Response to
Request for Additional Information No. 278, Supplement 6
9/14/2009

U.S. EPR Standard Design Certification
AREVA NP Inc.
Docket No. 52-020

SRP Section: 05.02.03 - Reactor Coolant Pressure Boundary Materials
SRP Section: 05.03.02 - Pressure-Temperature Limits, Upper-Shelf Energy, and
Pressurized Thermal Shock

U.S. EPR Pressure–Temperature Limits Methodology for RCS Heatup and Cooldown Report Markups

Figure 6-1 U.S. EPR RCS P-T Limits – Normal Heatup with ISLH and Criticality Limit Curves Applicable to 60 EFPY

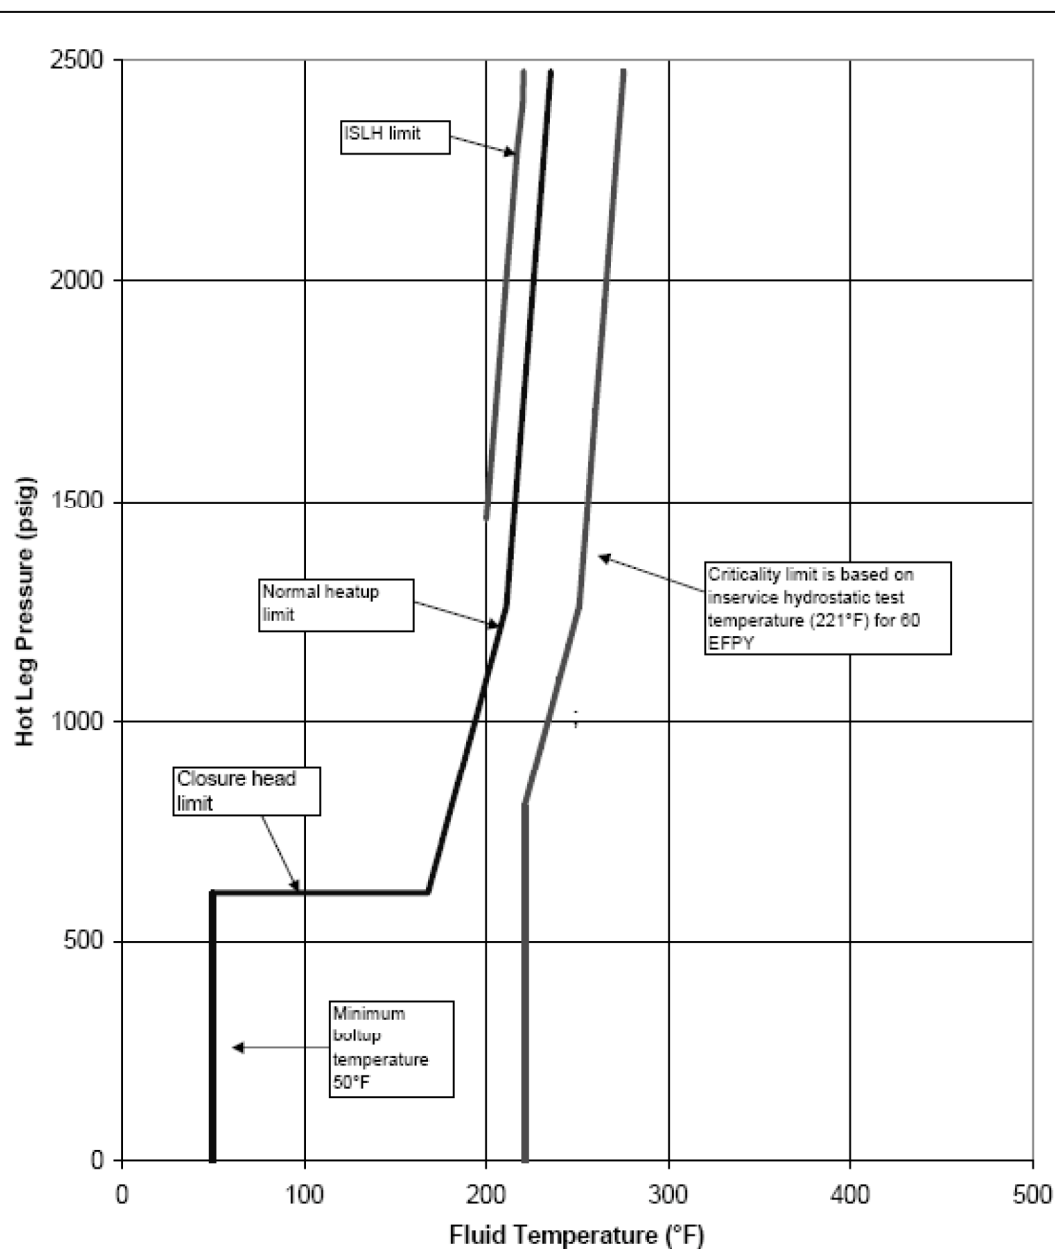
Provide a table of the data points (reactor coolant temperature vs. pressure) for each P-T curve displayed in Technical Report ANP-10283, Revision 1.

While preparing the response to this question, an error was identified in the criticality limit on Figure 6-1 in Technical Report ANP-10283P. This figure has been revised to eliminate the error. Table 05.03.02-7-1 contains the correct data points for the criticality limit.

Table 05.03.02-7-1—RCS Heatup Limits at 60 EFPY and Table 05.03.02-7-2—RCS Cooldown Limits at 60 EFPY contain the data points for Figure 6-1—U.S. EPR RCS P-T Limits – Normal Heatup with ISLH and Criticality Limit Curves Applicable to 60 EFPY and Figure 6-2—U.S. EPR RCS P-T Limits – Normal Cooldown Applicable to 60 EFPY in Technical Report ANP-10283P, “U.S. EPR Pressure-Temperature Limits Methodology for RCS Heatup and Cooldown,” respectively.

U.S. EPR FSAR Tier 2, Figure 5.3-1—Reactor Coolant System Heatup Pressure-Temperature Curve was also affected by the error identified in Figure 6-1. U.S. EPR FSAR Tier 2, Figure 5.3-1 was revised in U.S. EPR FSAR, Rev. 2 to eliminate the error.

05.-03-02-7
